Final Report
Value Engineering Study

Grand Avenue Bridge
CDOT Project No. FBR 0821-094(18158)

Prepared for
CDOT – Region 3

Dates of Study: November 4-8, 2013

Figure 3: Pedestrian Bridge Width Reduction:

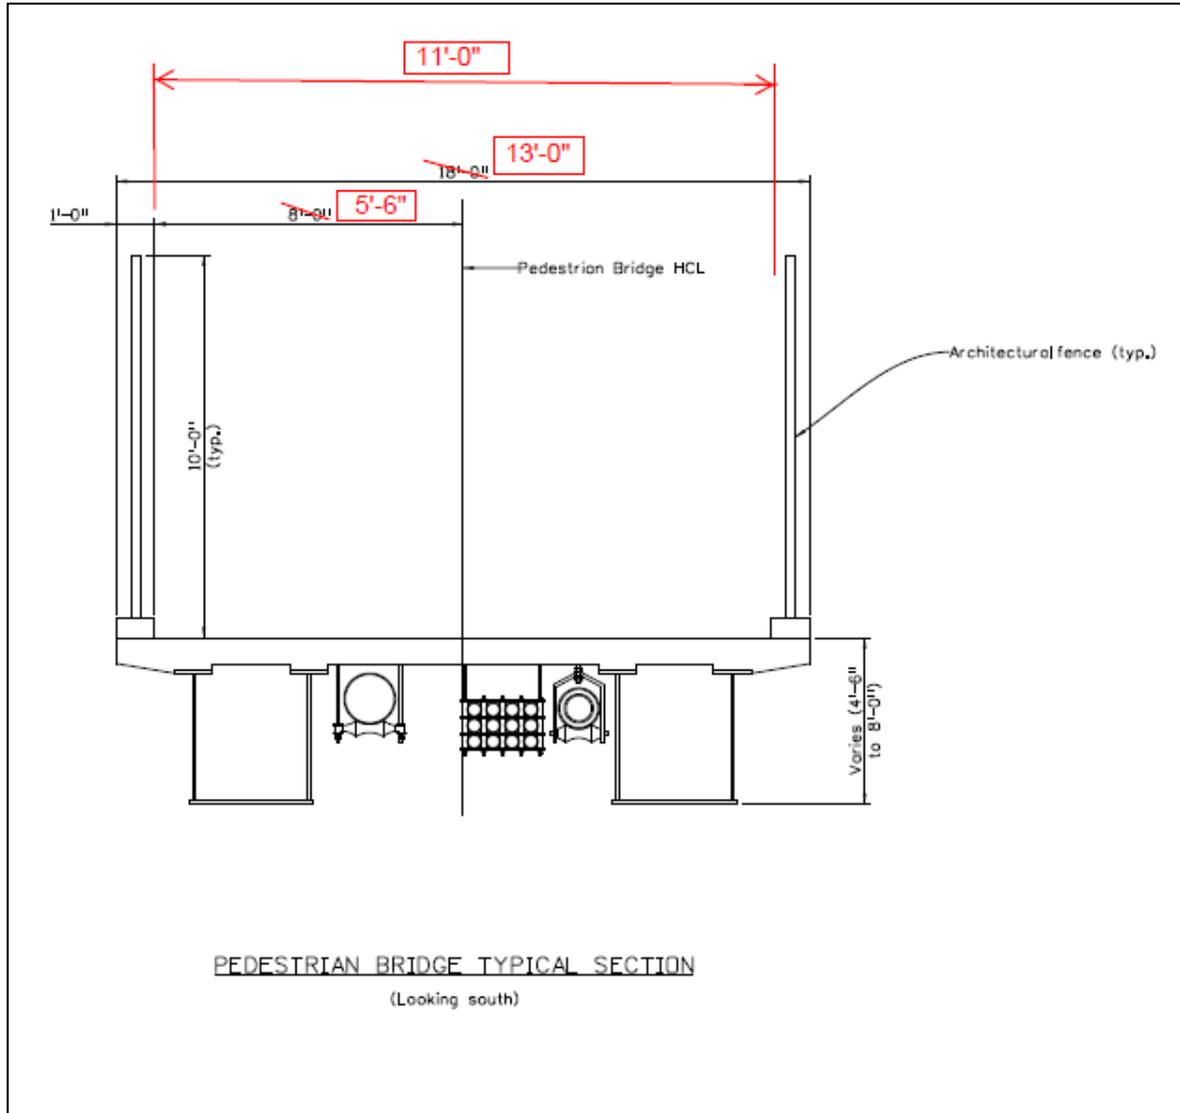
Reduced width Pedestrian bridge can be supported by superstructure girders required to carry less weight (dead load) and less user load (live load). With the reduction in applied loads, the girders would require less bending strength, less shear strength, and less stiffness to limit deflections, which results in reduction to girder member thicknesses, flange widths, and depth. The reduction in girder sizes achieves cost reductions. See Figure 3 for the reduced width Pedestrian bridge.

Two girder lines is still a feasible superstructure solution for the narrower Pedestrian bridge. The two girder lines still provide space between the girders for carrying utilities.

Value Engineering Proposal No. 41
SH 82 Bridge Curb Width Reduction
Recommended Action: Incorporate

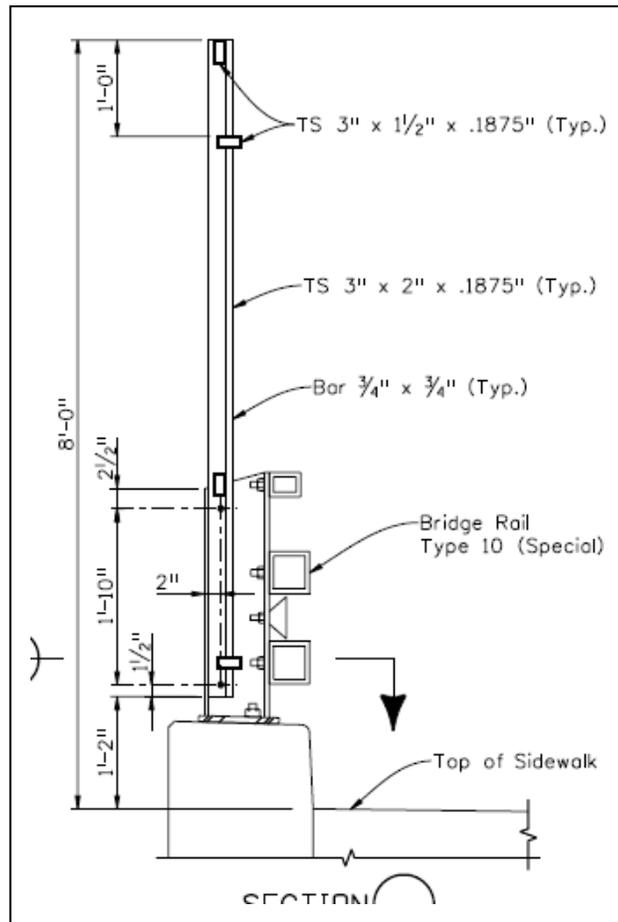
SH 82 bridge curb width could be reduced and the overall bridge deck width reduced, to achieve cost reductions. A narrower SH 82 bridge superstructure would be more efficient and less costly, thereby increasing value. The substructure abutments would also be shorter length and less costly.

SH 82 Bridge superstructure curb width could be reduced from 2' to 1.5', each side. Curb width 1.5' wide is adequate to accommodate the bridge rail that resists lateral vehicle loads and provide width to mount any potential fence or rail on the bridge rail posts. Pedestrians and bicycles are not intended to use the SH 82 Bridge, so there is no requirement to use fence in addition to the bridge rail to contain pedestrians or cyclists. The UPRR will require fence for the portion of the bridge superstructure over and near the UPRR tracks. The figure below shows an efficient bridge rail with fence mounted on the bridge rail posts.

41	SH82 Bridge curb width reduction Savings potential: \$100,000	<u>Decline</u> – Added 6” of deck for aesthetic edge. Not same cost as structural deck. Might be more like \$20,000 savings. Thin edge important for aesthetics.
46	Do not remove existing retaining walls Savings potential: \$25,000 to \$60,000	<u>Accept</u> – This makes sense although there may be some conflicts to work out.
52	Switch proposed walls to slopes Savings potential: \$200,000	<u>Reclassify as Design Consideration</u> – Aesthetics will need further evaluation.
